## Z-5 (2010)

SHEET TITLE  
**ZONING PLAN**

**PLANNING COMMENTS:** **Staff Member Responsible:** John P. Pederson, AICP

### Z-5 GOVENORS TOWNE SQUARE, LLC

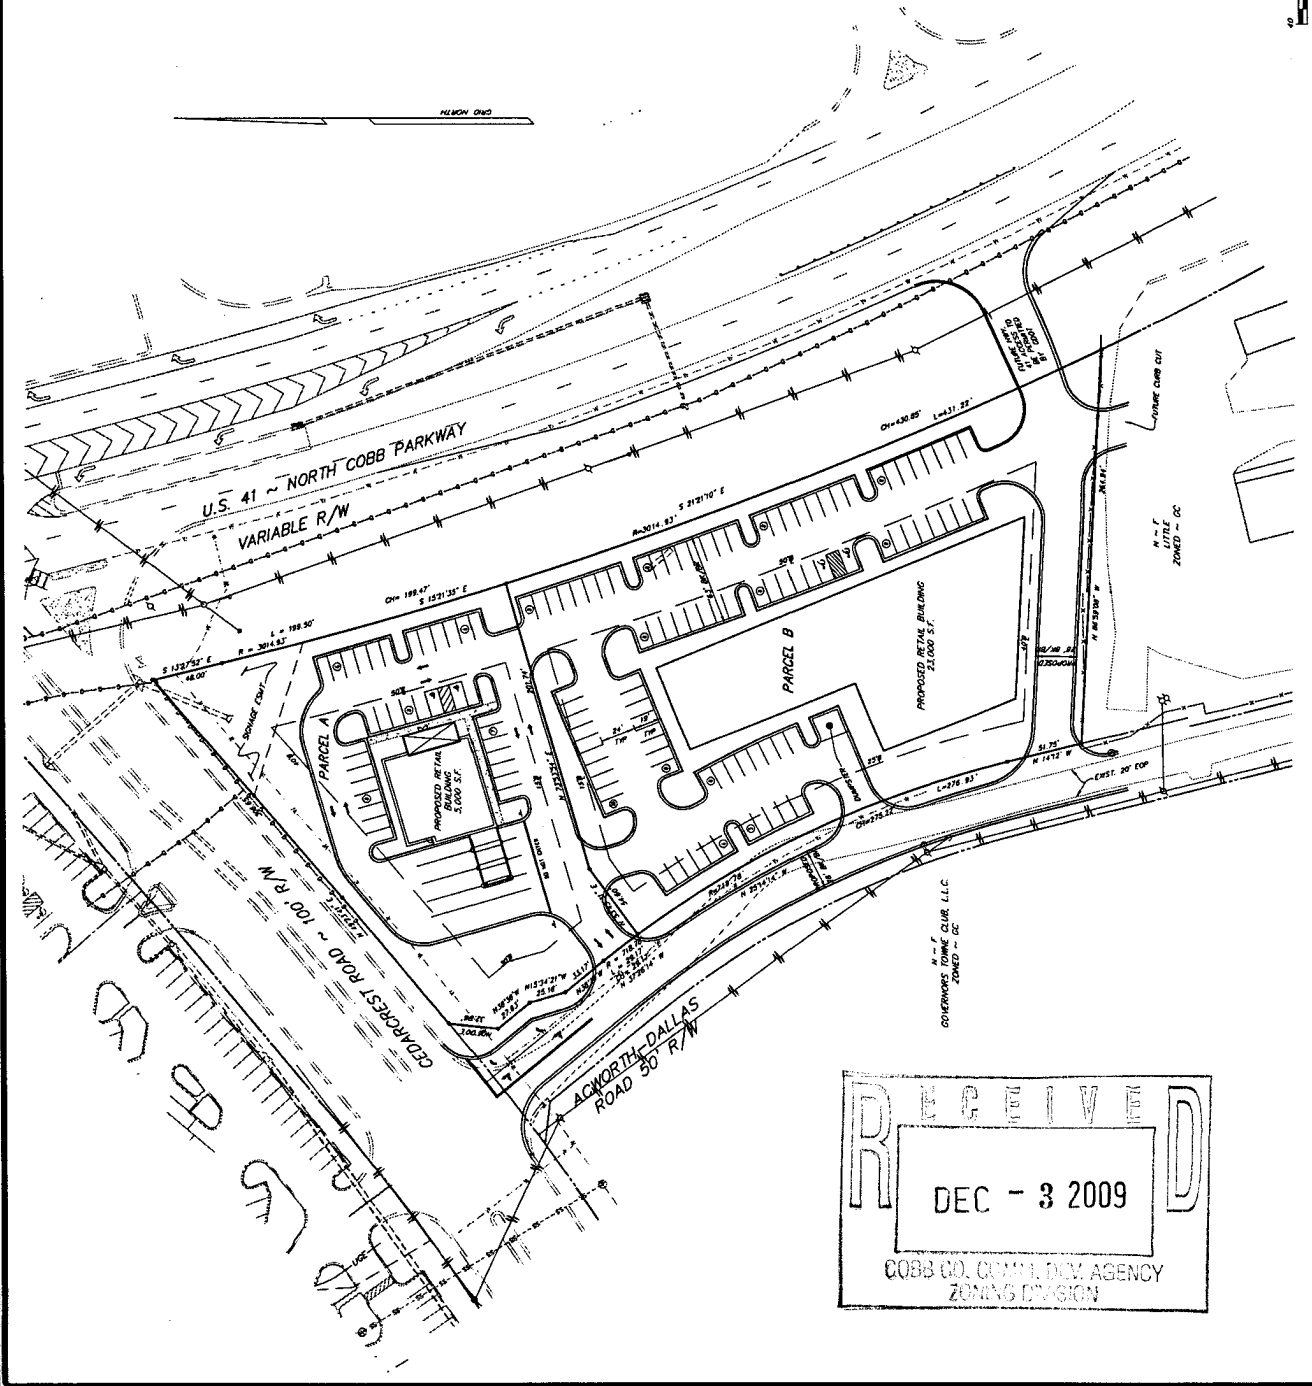
- No Stormwater controls shown \_\_\_\_\_
- Copy of survey is not current - Additional comments may be forthcoming when current site conditions are exposed.
- No site improvements showing on exhibit.

Acworth Dallas Road is not located as shown on the proposed plan. A right-of-way swap needs to be executed for the relocated Acworth Dallas Road.

Recommend right-of-way swap for Acworth Dallas Road right-of-way be completed.

- Site plan received by the Zoning Division December 3, 2009, with the District Commissioner approving minor modifications;
- District Commissioner approve the building architecture;
- Fire Department comments;
- Water and Sewer comments and recommendations;
- Stormwater Management comments and recommendations; and
- DOT comments and recommendations.
